## Tesoro Refining & Marketing Company LLC

July 17, 2023

**Subject: Comments on Amendments to R-307-110-13, Incorporation of Utah State Implementation Plan, Section IX.D.11: 2015 Ozone NAAQS Northern Wasatch Front Moderate Nonattainment Area, and Incorporation of Utah State Implementation Plan, Section IX.H.31 and Section IX.H.32: Emission Limitations and Operating Practices, R-307-110-17.**

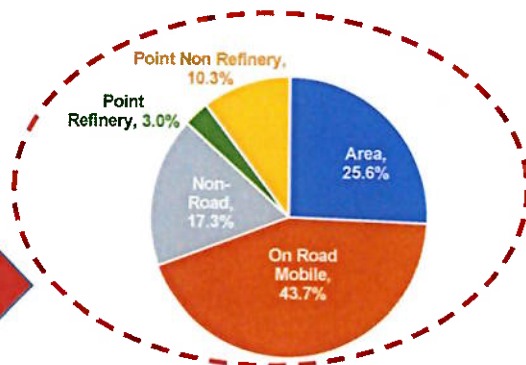
As shown in part A of the figure below, UDAQ's source apportionment modeling study shows that only 14% of the ozone during an episode (episode average) results from anthropogenic emissions *throughout Utah* (including point sources located in the NWF).<sup>11</sup> The remaining 86% of NWF ozone arises from additional sources that **cannot be controlled within Utah** including the following:

Point sources generate only a small portion of NWF ozone and the four major source petroleum refineries account for only a small portion of that, as shown in part B of the figure. The modeling study indicates that all point source emissions in the NWF account for approximately only 1 ppb of NWF ozone.<sup>13</sup> Presumably, this includes point source volatile organic compound ("VOC") and NOx emissions. The result is not surprising, for the following reasons:

**Figure 1. Ozone and 24-Hour PM<sub>2.5</sub> Long Term Trends**

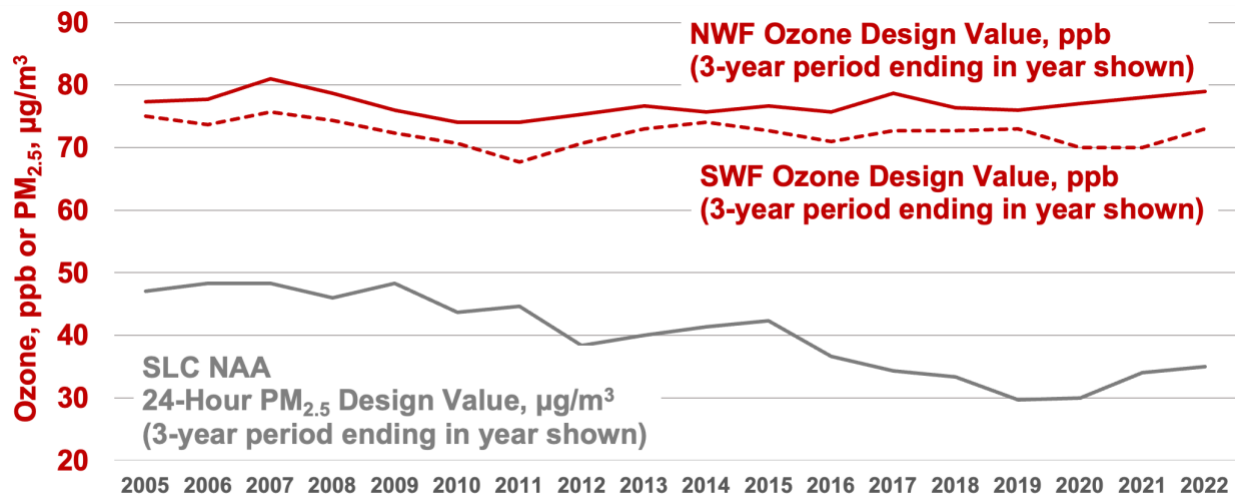
Despite the emission reductions, **Figure 1** shows that the ozone design value in the NWF has failed to improve even though the 24-hour PM<sub>2.5</sub> design value, which includes VOC and NO<sub>x</sub> as precursor emissions, shows a substantial long term improvement trend:

The proposed Moderate SIP makes no attempt to explain why the design value trend over the past twenty years would suddenly be responsive to new and very limited NO<sub>x</sub> and VOC reductions, significantly smaller than reductions over the past several years, and provides little or no evidence in support of the anticipated response. It is not enough to simply trust the model.

**Figure 1.** Monitored VOC:NO<sub>x</sub> ratios at Hawthorne using two different techniques using total non-methane hydrocarbons (TNMOC; top) and maximum incremental reactivity (MIR) weighted VOCs (bottom). Figure from Sghiatti and Daher (2022).

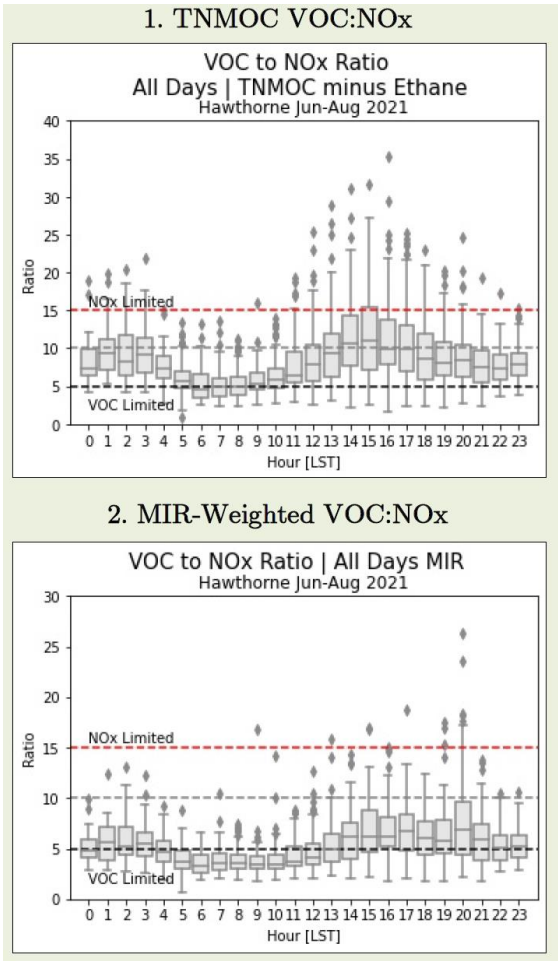
Under a Science for Solutions grant, Ninneman et al (2023) conducted photochemical box model simulations constrained by 2022 precursor and meteorological measurements at the Utah Technical Center during days influenced by wildfire smoke and on smoke-free days. The box model showed ozone production increasing during the morning hours and peaking around noon, after which ozone destruction processes dominated (Figure 2 below).

Therefore, VOC:NO<sub>x</sub> ratio is best evaluated during the morning hours (e.g., 6 AM to 12 PM), when Figure 1 indicates a more VOC-limited regime regardless of reactivity weighting. Box model sensitivity tests in which VOC and NO<sub>x</sub> precursor concentrations were systematically reduced separately and together showed strong responses to VOC and little response to NO<sub>x</sub> until very deep NO<sub>x</sub> reductions were applied (Figure 3 below) or reductions were applied collectively. Thus, results clearly show VOC-sensitive conditions at the Utah Technology Center, although that site measures some of the highest NO<sub>x</sub> in the area and so results in Figure 3 are not surprising.

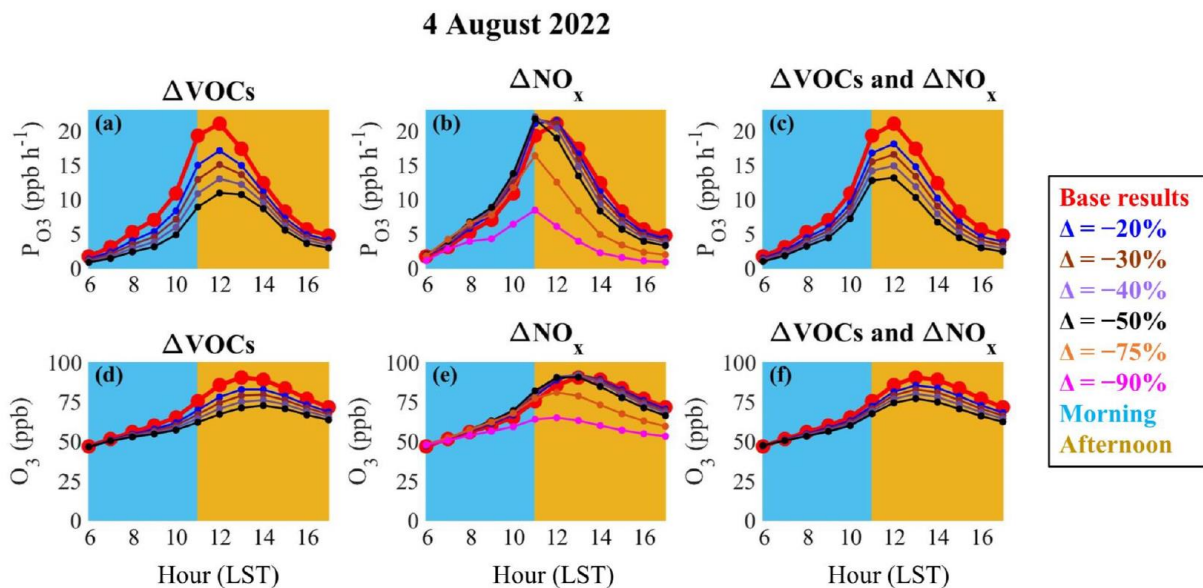
In summary, recent ozone and precursor analyses at two different monitoring sites indicate a stronger tendency toward VOC-limited photochemistry during hours of increasing and maximum ozone production, while CAMx shows a stronger tendency toward NOx-limited photochemistry. There are several possible reasons for this, as both techniques are associated with uncertainties: (1) since the model is not constrained by measured values (as box modeling is), error propagation stemming from uncertainties in emissions (values, time/space allocation) or meteorological inputs (chemical kinetics, vertical mixing, transport patterns) may cause an improper characterization of chemical sensitivity; (2) point measurements at monitoring sites sense local conditions but cannot provide information on how ozone is formed in other areas of the NWF NAA that are transported into the local monitored area. Both issues are likely at play to various extents, however, the documented CAMx performance issues throughout the modeling period weaken conclusions drawn from the modeling about NOx-sensitive conditions and strengthen conclusions about VOC-sensitive conditions drawn from the monitoring studies.

**Figure 6.** Average of Ramboll’s processing of MDA8 ozone contribution at Hawthorne over the top 10 days shown in Figure 4(a) from 6 aggregated “other point source” tracers. Contributions are split by whether ozone was generated by NOx (O3N) or VOC (O3V) sensitivity photochemistry.

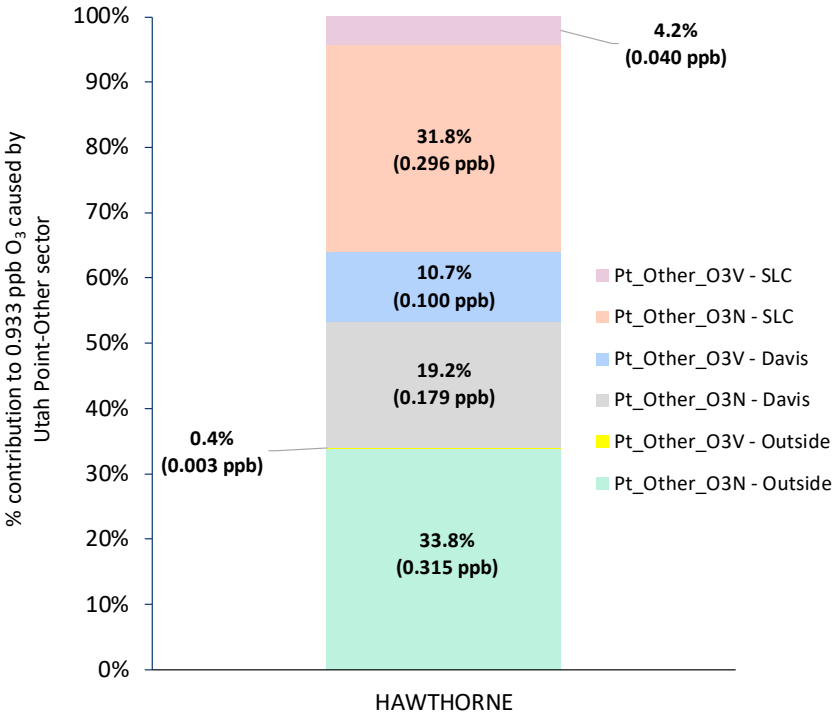
According to our results, the “other point source” category that contains refineries contributes a total of 0.9 ppb over the top 10 simulated MDA8 ozone days. Figure 6 shows a breakout of the 0.9 ppb contribution from “other point sources” by NOx (O3N) and VOC (O3V) sensitive ozone production, and from Salt Lake County, Davis County, and other areas outside the two counties. Point sources in Salt Lake County contribute 0.30 ppb (32%) and 0.04 ppb (4%) from NOx and VOC sensitive chemistry, respectively. Point sources in Davis County contribute 0.18 ppb (19%) and 0.10 ppb (11%) from NOx and VOC sensitive chemistry, respectively. For both counties, results indicate more NOx-sensitive ozone formation from point sources. All other point sources located throughout the remainder of the 4/1.33 km modeling domains contribute 0.32 ppb (34%) and <0.01 ppb (0.4%) from NOx and VOC sensitive chemistry, respectively. The stronger NOx-sensitive response from the outside point sources makes sense as they are mostly removed from the central urbanized area of the NAA, and thus ozone formation occurs in more NOx-lean and relatively biogenic VOC-rich suburban and rural areas.

We estimated the ozone impacts from simulated refinery control measures in 2023 at Hawthorne by multiplying contributions from Figure 6 by the relative emission reductions shown in Table 1. Results are shown in Table 2. The total simulated MDA8 ozone reduction from refinery measures averaged over the highest modeled ozone days is 0.02 ppb. Conceivably this impact would be smaller if the model simulated a VOC-sensitive environment rather than NOx-sensitive, as indicated by monitoring studies.
